STAFF REPORT
COMMUNITY DEVELOPMENT DEPARTMENT

HEARING DATE: March 26, 2024

SUBJECT: Farmstone Crossing Subdivision AZ, PP
[H-2023-0045](#)

LOCATION: 820 S. Black Cat Road in the Northwest ¼ of the Southwest ¼ of Section 15, T.3N. R.1W.

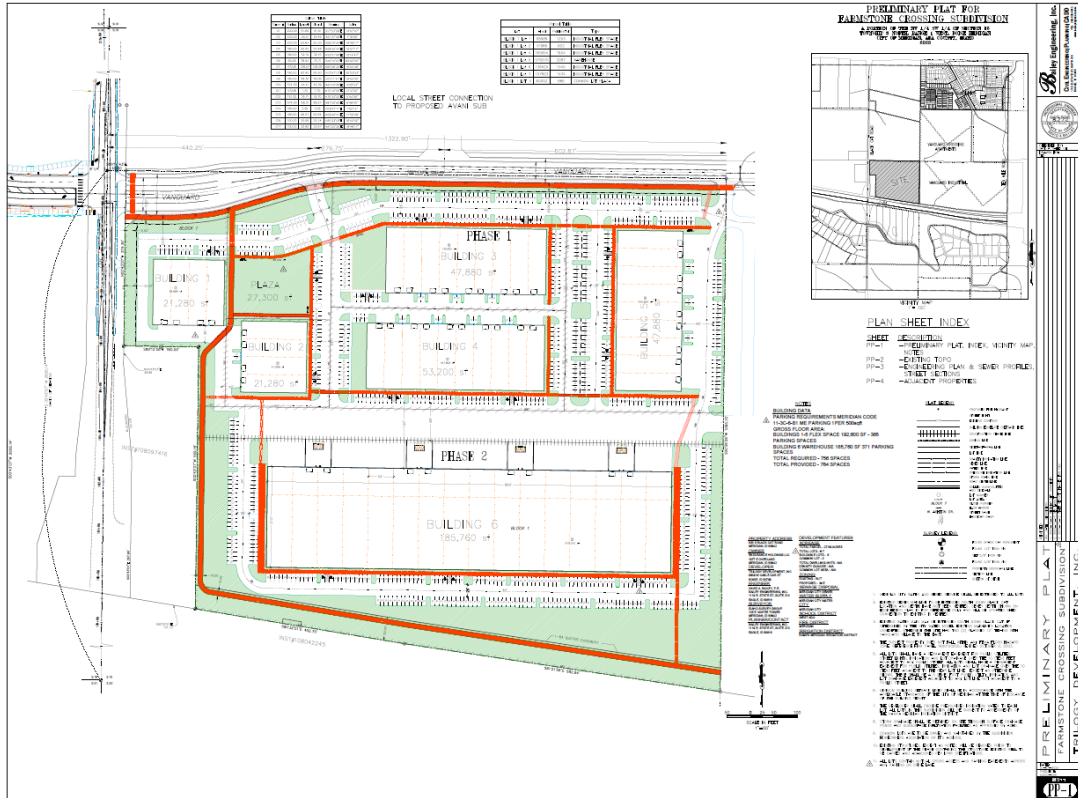
Vanguard Way should be constructed in accordance with Street Section C (major collector street) in the TMISAP, which requires (2) 11-foot travel lanes, 6-foot bike lanes, 8-foot parkways with streetlights at a pedestrian scale, and minimum 6-foot wide detached sidewalks (see pg. 3-20, 3-22, 3-23). The Applicant proposes a modification of the street section to include 10-foot wide detached sidewalks/pathways in lieu of on-street bike lanes, which is required by ACHD and as set forth in the Meridian Master Pathways Plan.

All streets should be constructed as complete streets as defined in the TMISAP (see pg. 3-19 & 3-20). Prior to submitting the final plat, the Applicant shall coordinate with the property owner to the north and east to construct Vanguard Way and deed the right-of-way to ACHD. The Applicant should ensure that the intersection of Vanguard Way and S. Black Road aligns with the entrance of the Black Cat Industrial projects on the west side of S. Black Cat Road.

- c. Depict street sections for Vanguard Way consistent with Street Section C in the TMISAP with a modification that allows (3) 11-foot travel lanes, 8-foot parkways and detached 10-foot wide sidewalks/pathways in lieu of on-street bike lanes as required by ACHD. Streetlights are required at a pedestrian scale, unless another alternative is approved (see pg. 3-20, 3-22, 3-23).

FIGURE 1

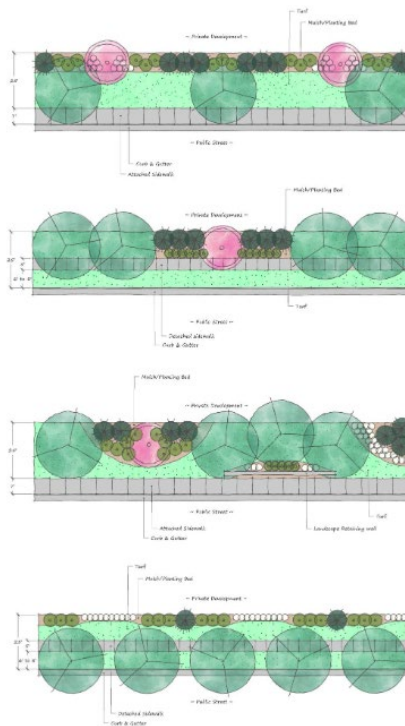
The Applicant should revise the landscape plan to reflect landscaping within the required buffers along Vanguard Way and Black Cat Road adjacent to the drainage swale in front of the 10-foot pathway in accordance with the standards listed in UDC [11-3B-7](#), which requires a variety of trees, shrubs, lawn or other vegetative groundcover (see figures below).

- a. Depict landscaping within required street buffers along Black Cat Road adjacent to the drainage swale in front of the 10-foot pathway and Vanguard Way in accord with the recently amended standards listed in UDC [11-3B-7C](#) and [11-3B-8C](#); all required landscape buffers along streets shall be designed and planted with a variety of trees, shrubs, lawn, or other vegetative ground cover. Plant materials in conjunction with site design shall elicit design principles including rhythm, repetition, balance, and focal elements

D. Landscape Plan Rendering

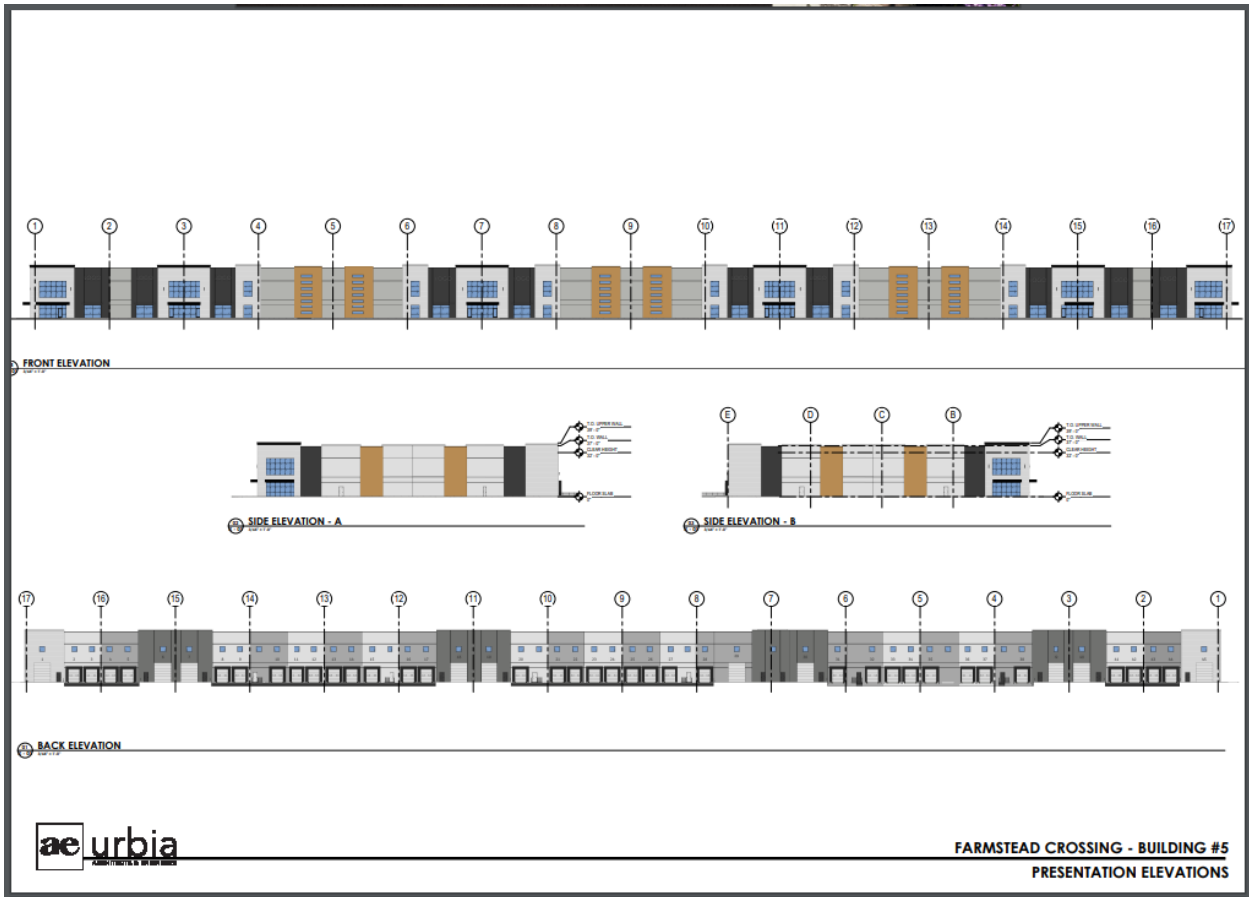
Street buffers are required to be provided as set forth in UDC [Table 11-2A-7](#). A minimum 25-foot wide street buffer is required along all arterial streets (i.e. S. Black Cat Road) in commercial districts. A 20-foot wide street buffer is required along all collector streets (i.e. Vanguard Way) – the buffer may be placed in an easement rather than a common lot in accord with UDC 11-3B-7C.2a. A minimum 50-foot wide street buffer is required along I-84, landscaped per the standards listed in UDC [11-3B-7C.3](#), which requires a variety of trees, shrubs, lawn or other vegetative groundcover (see updated code for specifics & figures below). **The proposed buffer dimensions appear to meet the requirements of the UDC code; however, there is a lack of a combination of planters (shrubs and rock mulch) within the buffer along Vanguard Way. The Applicant has provided fifty-two (52) trees and only thirty-four (34) are required along Vanguard Way. Staff recommends that the Applicant enhance the street buffer by reducing the number of trees and incorporating additional planters. The landscape buffer along Black Cat Road adjacent to the open drainage swale, lacks vegetation in front of the 10-foot pathway, not meeting the requirements of the UDC.**

Mitigation is required for all existing trees 4” caliper or greater that are removed from the site in accord with the standards in UDC 11-3B-10C.5. Mitigation calculations are depicted on the landscape plan in accord with UDC standards (i.e. 149 trees at 2 caliper inches each for a total of 284 caliper inches). **The location of mitigation trees shall be depicted on a revised landscape plan submitted with the final plat application.**

- c. The location of mitigation trees shall be depicted on a revised landscape plan submitted with the final plat application.
- 2.4 A 14-foot wide public use easement for the multi-use pathways within this site shall be submitted to the Planning Division prior to submittal for City Engineer signature on the final plat(s).

E. Pedestrian Circulation Plan

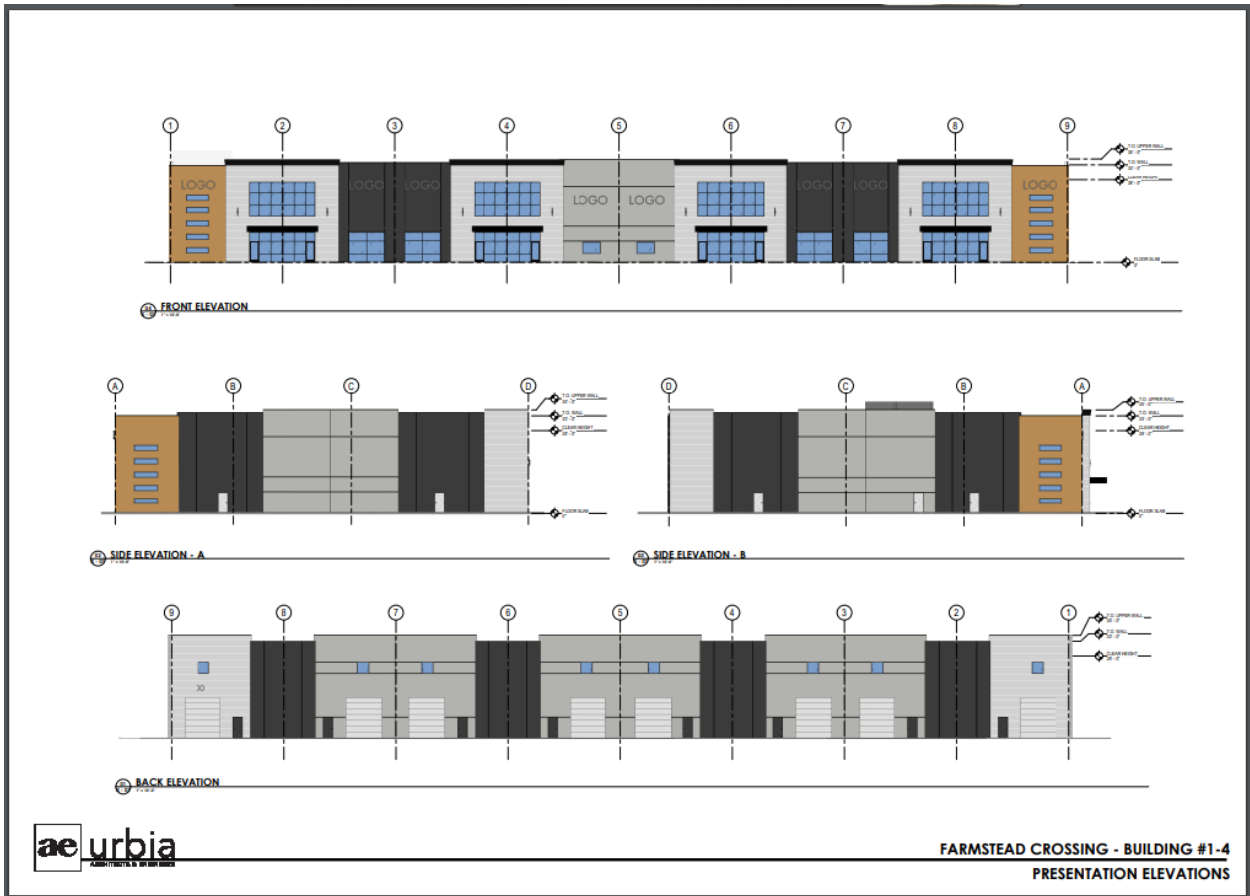
Ten (10) foot-wide multi-use pathways are proposed on the site in accordance with the Pathways Master Plan. One segment follows Vanguard Way across the northern portion of this site; one segment runs along the southern boundary within the street buffer along I-84; and another segment runs along the west side of the site adjacent to S. Black Cat Road to the plaza on the north. **The proposed pathway is intended to cross the drive aisle between Buildings 1 & 2**

(refer to figure below). Staff recommends removing the loading docks from the rear of Buildings 1 & 2 to mitigate potential conflicts between pedestrians using the pathway and delivery trucks accessing that area. A 14-foot wide public use easement for all multi-use pathways shall be submitted to the Planning Division prior to submittal for City Engineer's signature on the final plat(s).

- a. Development of the subject property shall be generally consistent with the site plan, landscape plan, preliminary plat, phasing plan, and conceptual building elevations included in Section VII and the provisions contained herein. **Prior to the Council hearing, the Applicant shall provide elevations for Building #1 and Building #2 incorporating a more traditional office design to complement the plaza area. Additionally, the Applicant shall remove the loading docks from the rear of the buildings in favor of more parking.**
